**Application No.**  
P/18/0257

**Proposed Development**

Residential development

Land North Of Pant  
Industrial Estate  
Bryniau Road  
Pant  
Merthyr Tydfil

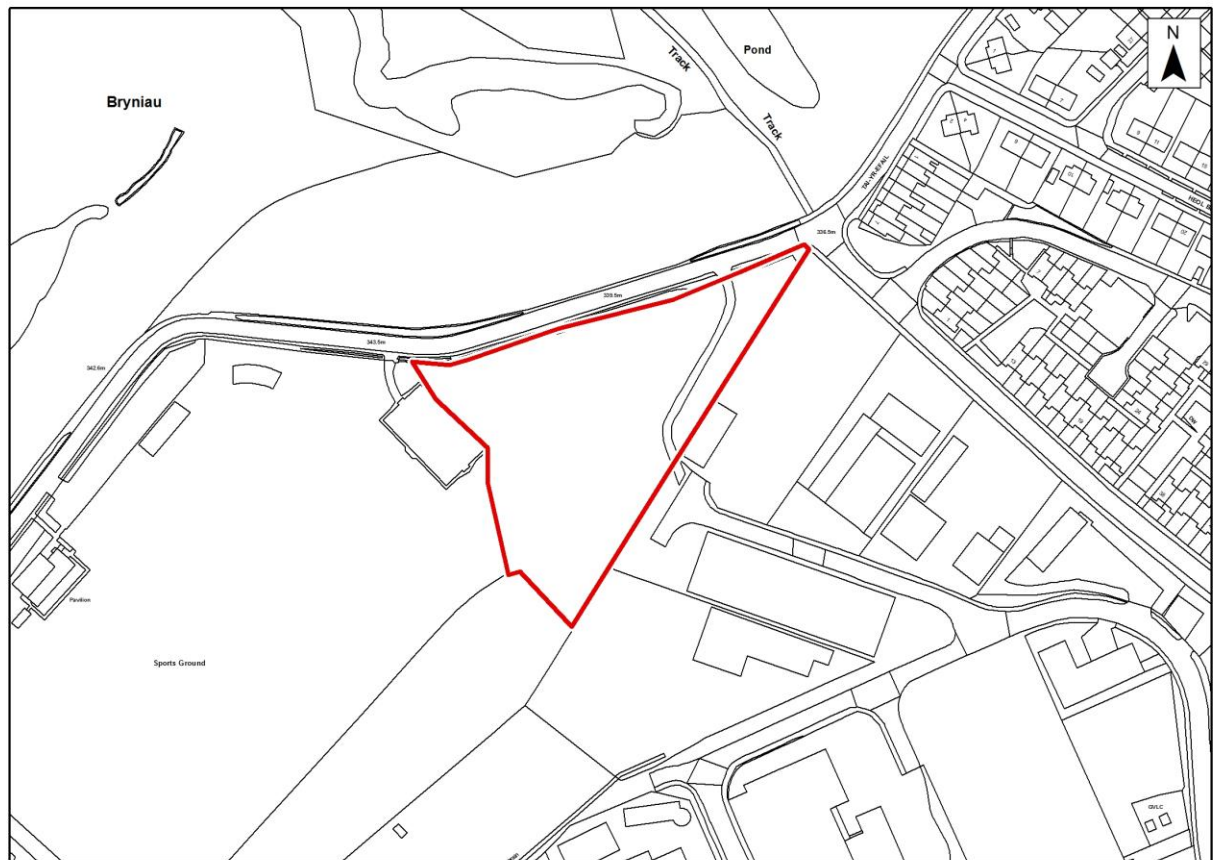
It would appear from the layout plan that there is an intention to provide a prominent frontage onto Bryniau Road in the form of terraced properties, which would follow a similar pattern of development further along the highway to the north-east. In response to the change in levels, with the highway being elevated above the site, the indicative sections suggest the ground floor levels of the terraced properties (Plots 19-32) could be raised, to incorporate a garage at the lower ground level. However, in order to gain access to these garages, it would require vehicles to traverse the length of the rear garden areas.

The layout elsewhere within the site appears to be largely informed by the need to provide a suitable means of access with appropriate gradients. Taking into account the topography, the semi-detached dwellings on plots 1- 12 are logically suggested in rows along the south-west and south-east boundaries, where they could gradually step down and front onto the new access road. Additionally, it would appear that dwellings have been avoided in the area immediately next to the industrial unit that abuts part of the south-east boundary, to minimise potential impacts on residential amenity.

There are concerns with the potential siting of dwellings at the centre of the site. It has been demonstrated on the layout plan that the dwellings on plots 13-18 could be positioned a sufficient distance away from the neighbouring properties to avoid overlooking concerns. A frontage on to the access road could also be provided to reinforce the streetscene opposite plots 9-12. However, in doing so, the semi-detached dwellings (plots 13-18) and the terraced properties (plots 19-33) would both back on to the service road creating dead frontages on either side of the carriageway. The streetscene along this section of the site would consequently be dominated by a combination of high boundary fences to secure private garden areas and parked vehicles. Furthermore, this part of the development, including the visitor parking bays adjacent to the turning area, would lack any reasonable natural surveillance. This poor relationship between plots would create a visually harmful and unwelcoming residential environment.

It is suggested on the layout plan that an area of open space could be created in the southern corner of the site, which could be utilised to provide a drainage swale. There is no clear indication in the DAS to explain why this part of the site was chosen to accommodate an area of public space. Nor are there details to help explain how the swale would complement a sustainable drainage scheme (SUD) for the development, which may otherwise inform its potential location. Although the provision of an area of public space and the incorporation of a SUD scheme is welcomed, the layout plan fails to demonstrate how

this could form an integral part of the development. Indeed, as illustrated on the layout plan, the public space would be poorly overlooked, which raises concerns with the potential for this space to attract anti-social behaviour.

It is acknowledged that the Landscape Architect has raised concerns in relation to the layout of the development. In this respect, it has been suggested that a soft boundary treatment along the main highway would be a more appropriate response on the border of the open countryside. The Landscape Architect has also suggested that the open space would be better located within a more centralised area of the site to add setting and character to the development. This would also enable it to form an integral part of the proposal.

Furthermore, it is acknowledged that the South Wales Police have also commented on the poor layout of the proposal, which would render various parts of the site vulnerable to anti-social behaviour. This is particularly due to the poor orientation of the buildings in relation to the public realm, resulting in a lack of suitable natural surveillance.

Overall, there are a number of concerns with the indicative layout, which fails to adequately demonstrate how the development of the site can achieve an appropriate design. It should be noted that the concerns highlighted above were previously raised as part of a pre-application response (PA/18/0033). However, the main issues in respect of street frontages and the location of the public open space have not been addressed. Considerable alterations may be required to enable a more suitable layout, which may impact on the number of residential units, key frontages and the arrangement of public/private spaces. Therefore, the indicative layout does not adequately demonstrate how the development would meet the requirements of policy BW7 of the LDP, which seeks to secure good quality sustainable design.

1. It has not been adequately demonstrated that the site can be developed in a way which effectively integrates with both the internal and surrounding environments. There is insufficient evidence to suggest that the development could provide appropriate active street scenes with integrated public open spaces. As such the proposal would fail to create a good quality, well designed and safe environment contrary to Policy BW7 of the Merthyr Tydfil Local Development Plan.
